LEESTON PLAN CHANGE - RFI RESPONSE

Thank you for your letter dated 19 September requesting further information regarding Plan Change PC190062: Private Plan Change Leeston. Baseline Group has prepared the following response.

Leeston Plan Change

Appendix 4: Outline Development Plan

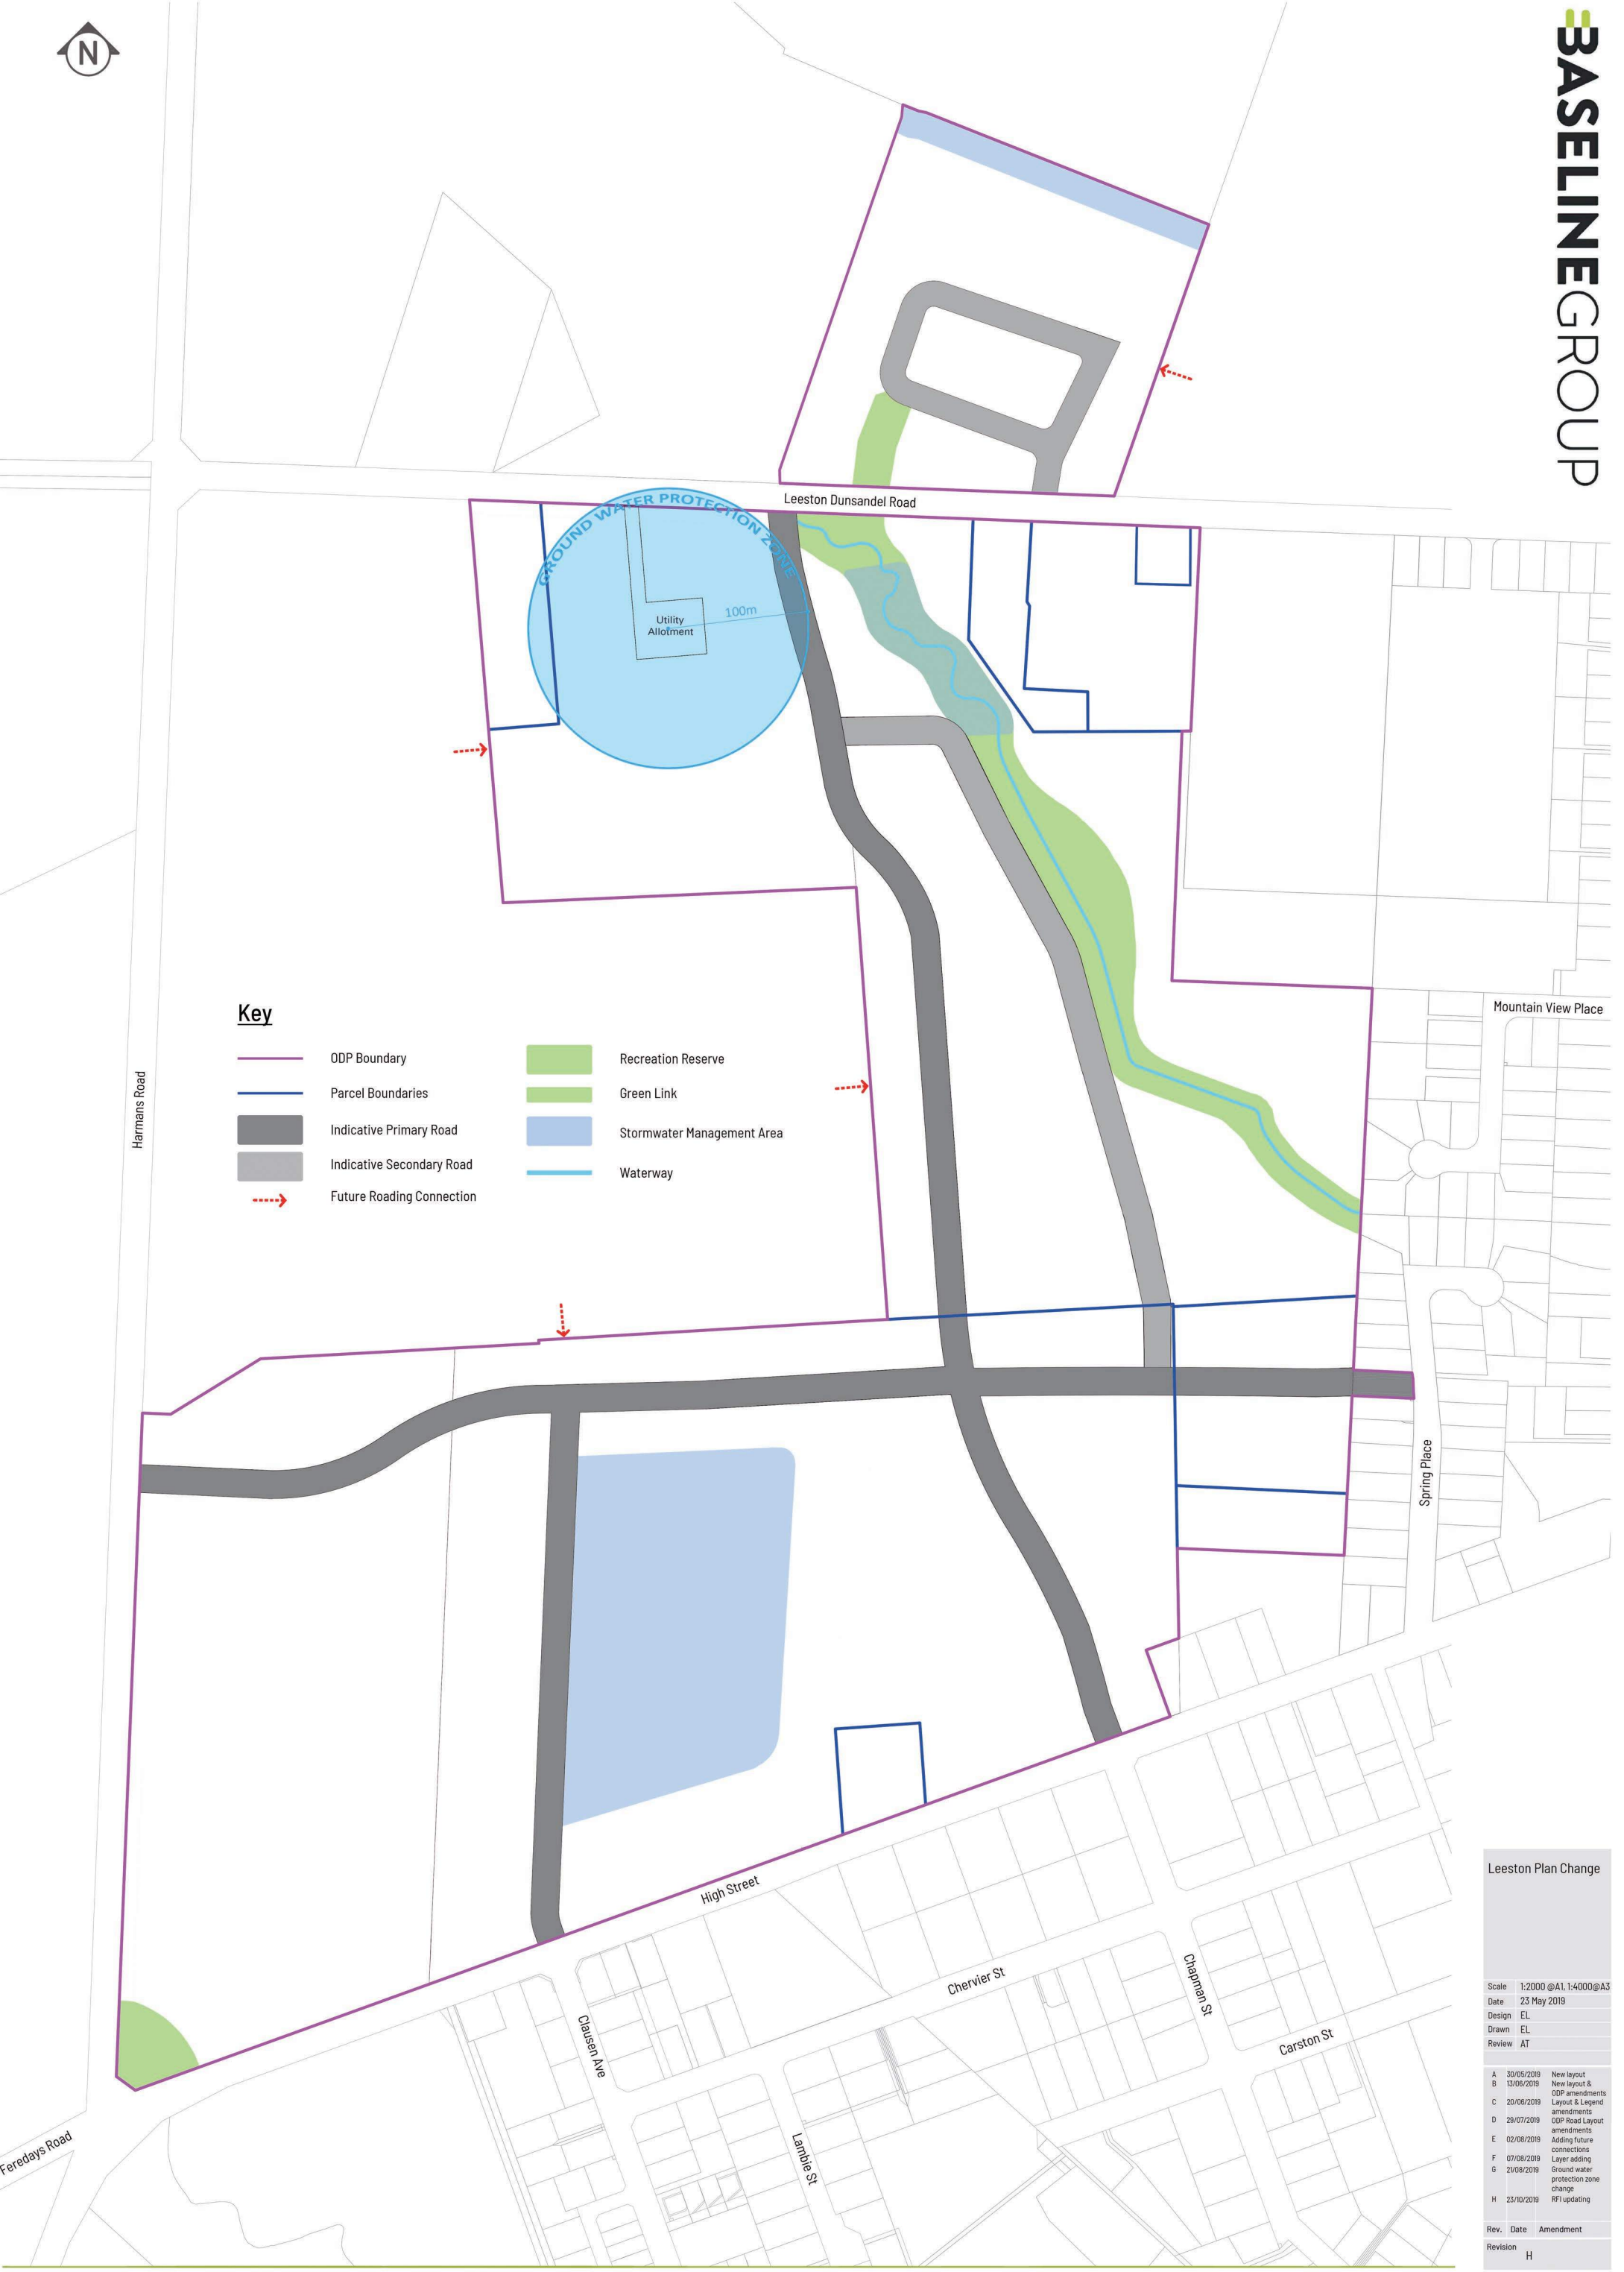
12. As highlighted in yellow below, the ODP should show a specific pedestrian/cycle link along the main reserve/water course alignment. The ODP should also show a pedestrian/cycle link from the northern part of the to the future stormwater reserve area along the northern boundary of the site.

17. There are small inconsistencies between the overall ODP and the transport network in terms of the pedestrian/cycle links. Please resolve these. It is noted that a continuous alignment is preferred.

19. The names of the surrounding roads should also be shown on the ODP.

22. The ODP should be amended to reflect any matters raised in the points above, particularly regarding roading and reserves.

These have been added to the ODP and a revised copy of the ODP is attached in Appendix 4.

The ODP has been amended to resolve the inconsistencies between the overall ODP and the transport network plan and is attached in Appendix 4.

Road names have been added to the ODP plans in Appendix 4.

The ODP plans have been amended and are attached to this letter in Appendix 4.
